Debonair Ltd Unit-2

Plot 356, Ozarpara, Sharifpur Road, Maleker Bari, Gazipur
(23.963308N, 90.366508E)
17th May 2014

Observations

Column schedule

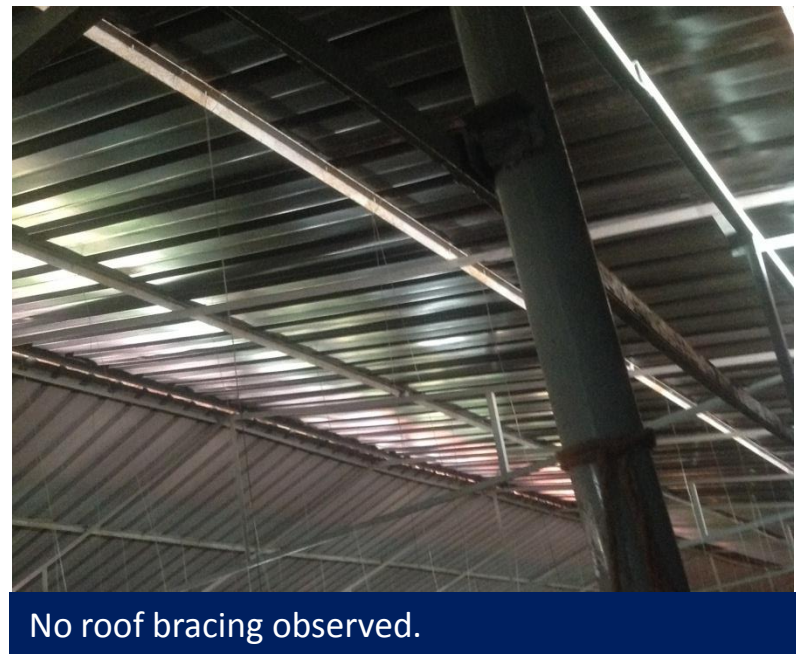
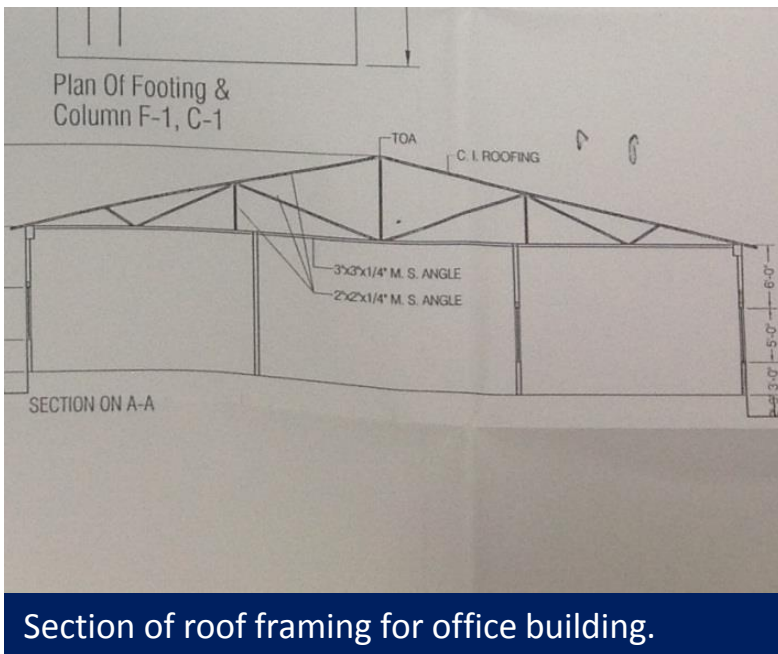
Cursory calculations indicate that the working stresses to the Ground Floor and First floor columns are at a high level. Building Engineer to review design, loads and columns stresses.

Column sizes in schedule are bigger than those observed on site

Tested Ground Floor Column (Type C-1)

Tested Ground Floor Column (Type C-2)

Cracking of stairs

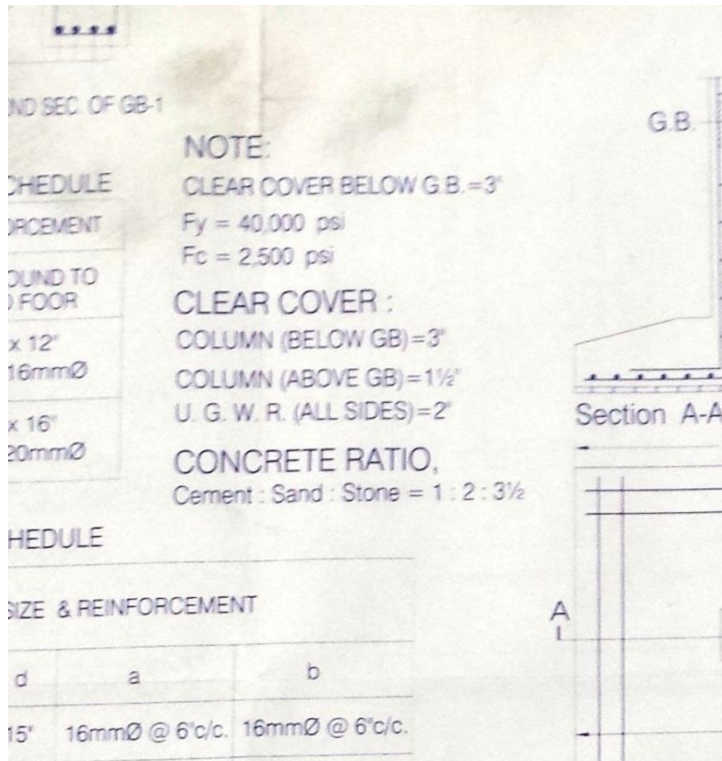
Cracking was observed to the stairs of the building under construction at the connection with the supporting masonry wall. Building Engineer to investigate the cause and extent of cracking. Building Engineer to advise if load reduction, repair and strengthening of the stairs is required.

Cracking

Inconsistencies in Documents Provided and absence of Loading Plan

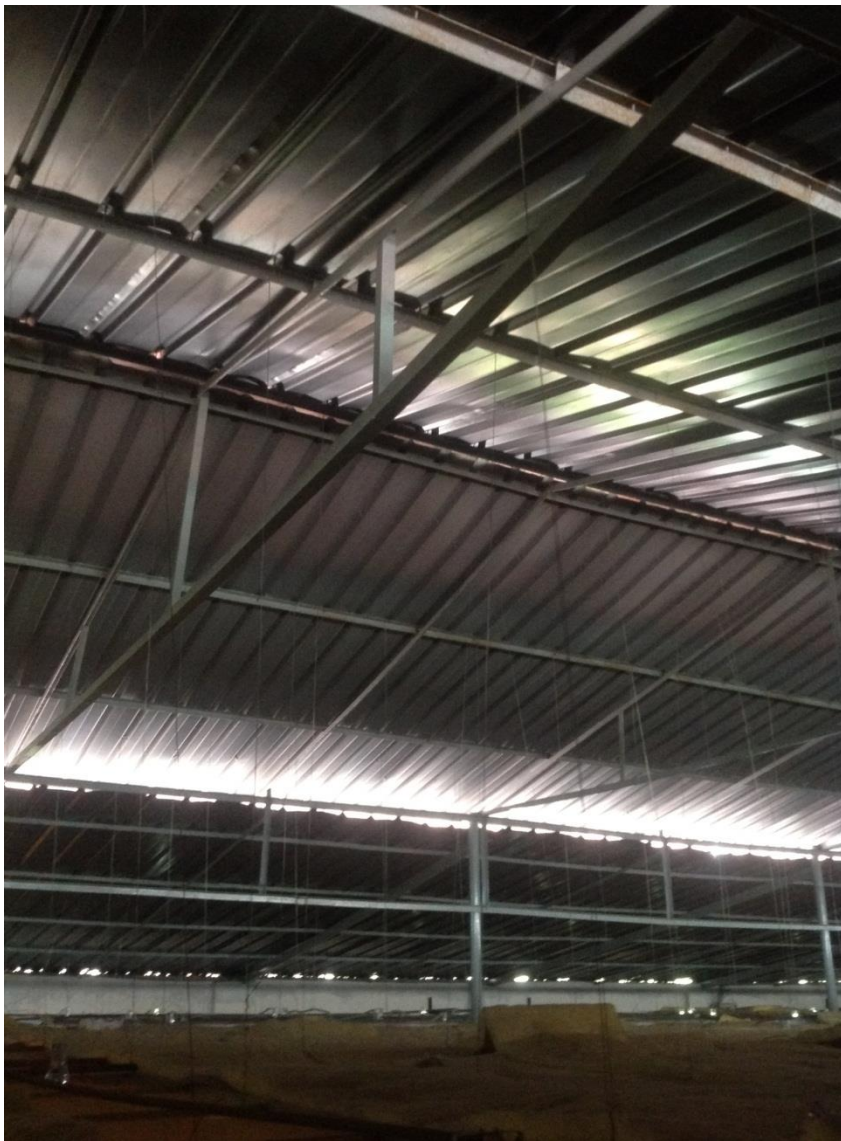
There are a number of inconsistencies between the permit drawings and the constructed buildings, principal of which are that brick aggregate was used where stone aggregate is specified and column sizes are smaller than specified. There were also differences between the observed floor occupancy and that shown on drawings. Building Engineer to provide an updated Permit drawing and a full set of as-built structural and architectural drawings for all of the buildings on the site.

Stone chip aggregate specified.

Brick aggregate was observed on site.

Inconsistencies in Documents Provided and absence of Loading Plan

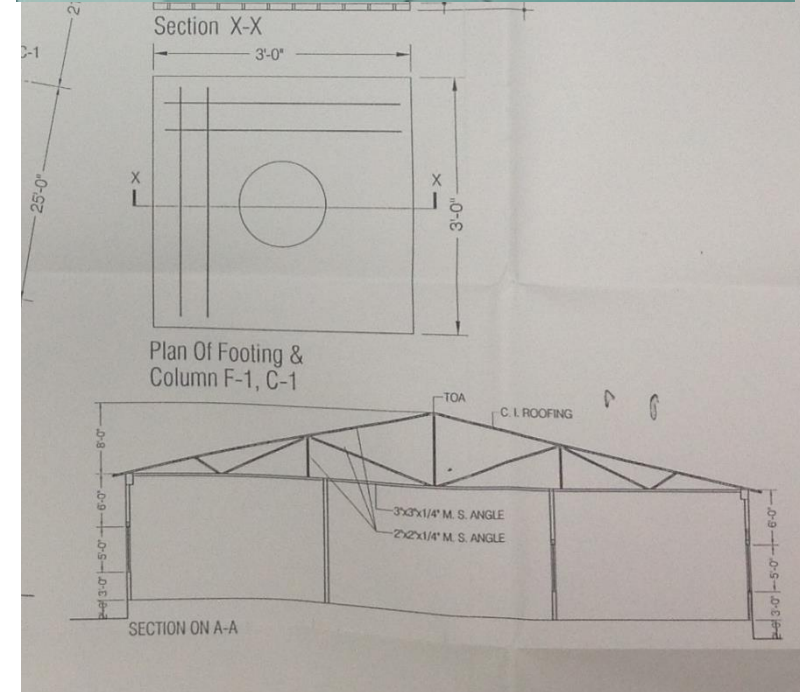
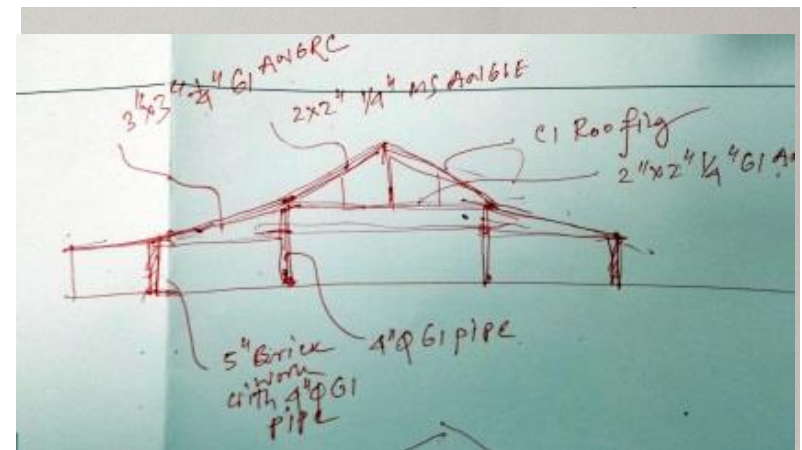
Diagonals missing from office building roof truss.

Drawing specifying diagonals in roof truss.

Inconsistencies in Documents Provided

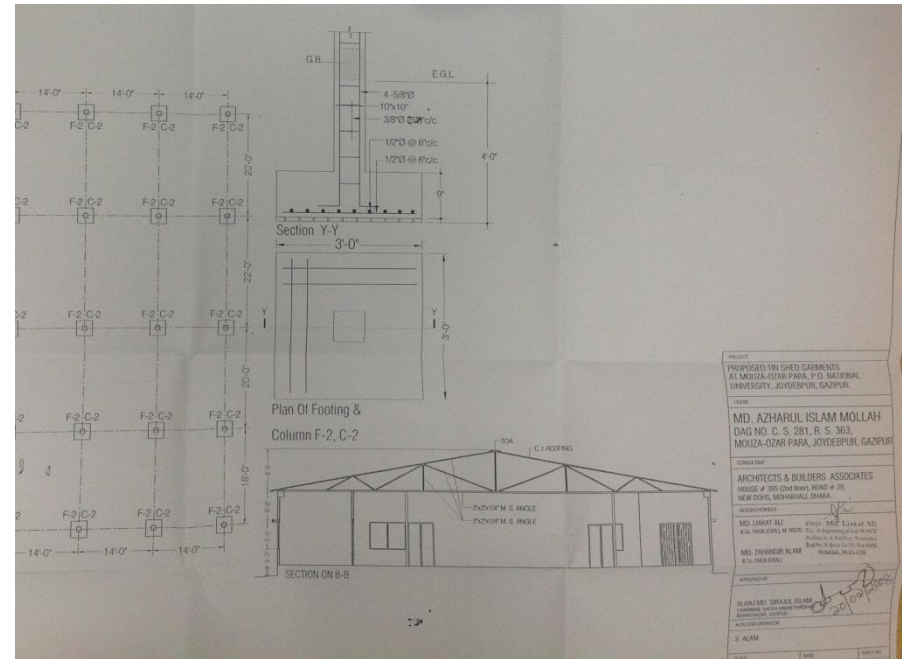
No roof trusses were observed in the Shed 2.

Drawing specifying trusses in roof.
